# Planning Approval Consistency Assessment Form

<b>Assessment Name:</b>	Parramatta Station temporary through-site connection
<b>Prepared by:</b>	Sydney Metro
<b>Prepared for:</b>	Sydney Metro stations contractor
<b>Assessment number:</b>	SMW13
<b>Type of assessment:</b>	Assessment under EP&A Act 1979, Division 5.2
<b>Version:</b>	Final
<b>Planning approval No. (where relevant):</b>	SSI-22765520
<b>Date required:</b>	30 August 2024
<b>iCentral number</b>	SM-24-00019392

## Appendix A – Indicative Parramatta metro station construction site (approved project)

Figure A Indicative Parramatta metro station construction site (approved project)

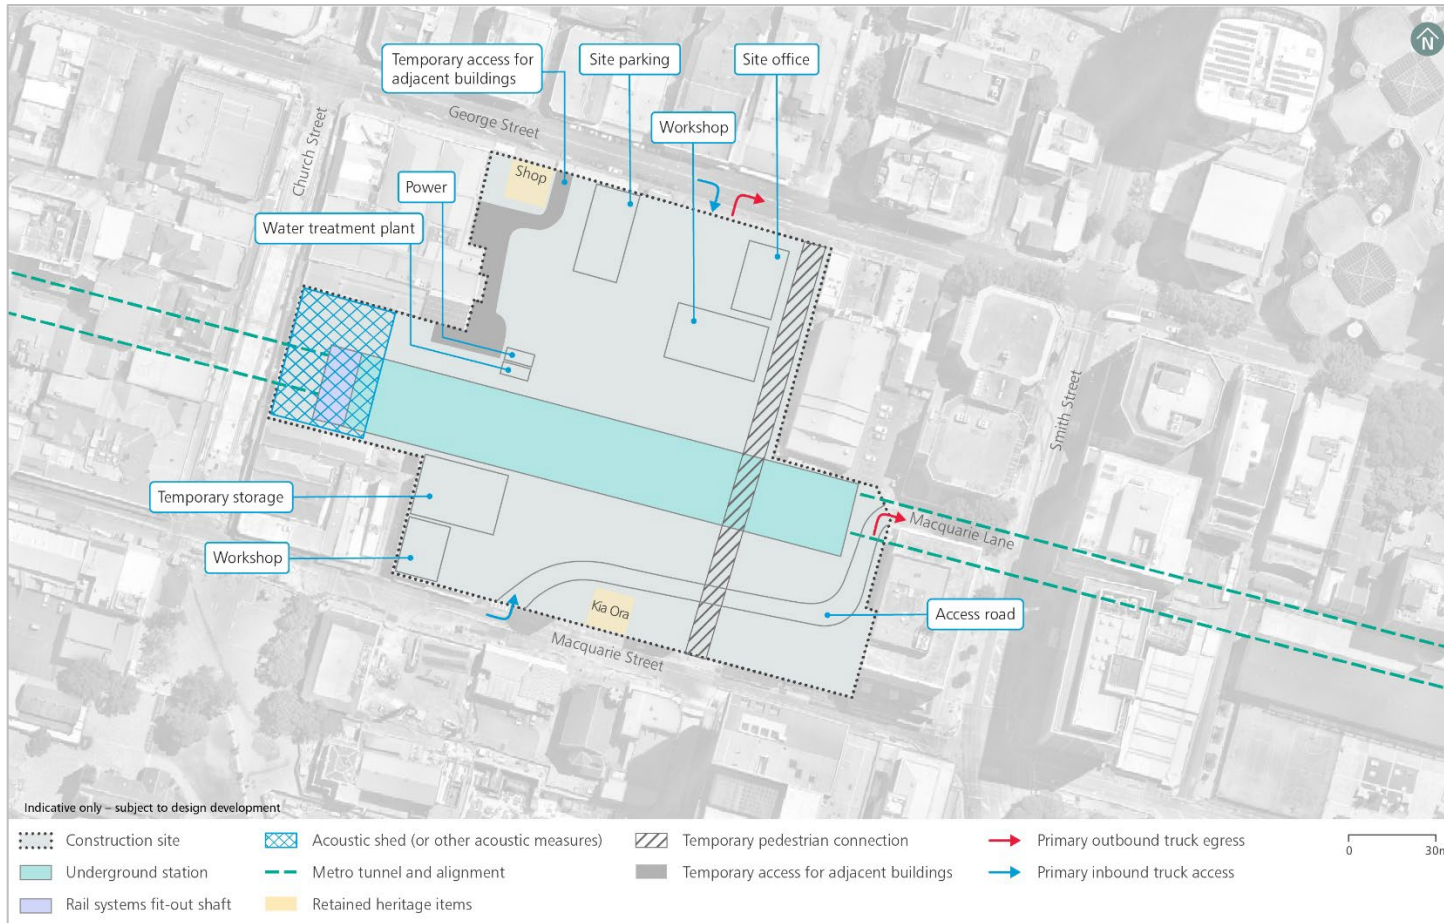
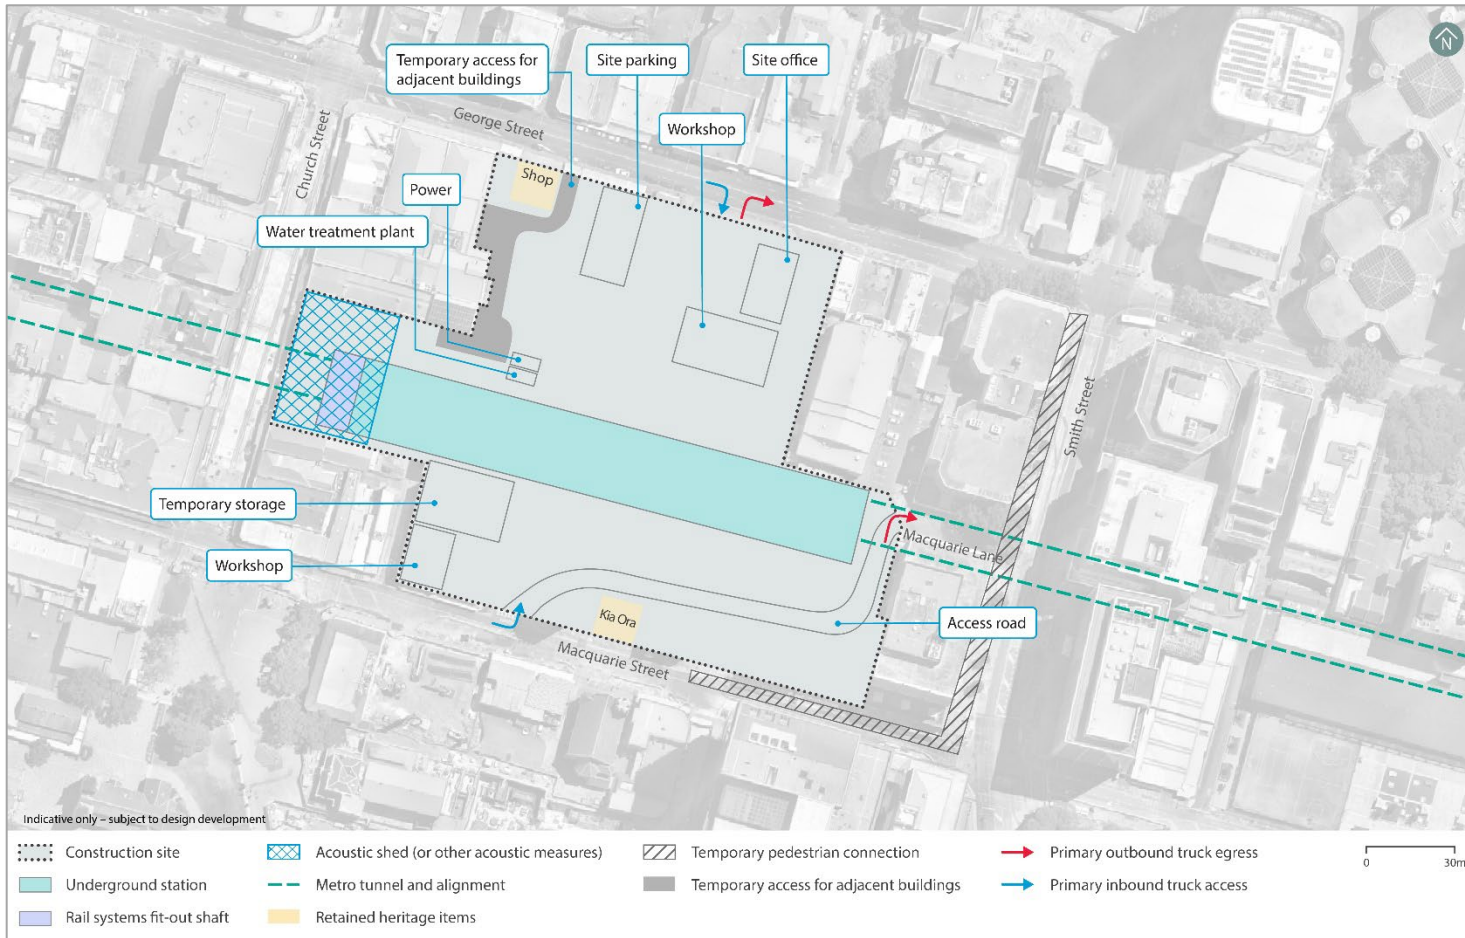
The proposed change relates to the descoping of a temporary pedestrian connection through the Parramatta metro station construction site. The approved project's Revised Environmental Mitigation Measure (REMM) EIS-TT18 stated that a temporary north-south pedestrian route would be provided between Macquarie Street and George Street at the Parramatta metro station construction site, with some short-term closures potentially being required. This arrangement was pictured in Figure 4-9 of Section 4.0 of the Revised Proposal Description (Appendix B of the RtS) where a temporary pedestrian connection was shown running through the Parramatta metro station construction site in the general location of the future Civic Link. The approved project outlined that construction site layouts at each station location were indicative, with potential for changes to occur following detailed construction planning.

As an alternative to the temporary through-site connection assessed for the approved project (Appendix A), pedestrians travelling on George Street and Macquarie Street would travel about 90 metres east from the general location of the future Civic Link towards Smith Street. This would be a continuation of the existing arrangement established under the previous planning approval (Concept and Stage 1) and has been agreed with City of Parramatta Council through ongoing consultation.

The indicative construction site layout and temporary through-site connection assessed for the approved project is shown in Appendix A. The revised temporary pedestrian connection subject of this consistency assessment is shown in Appendix B.
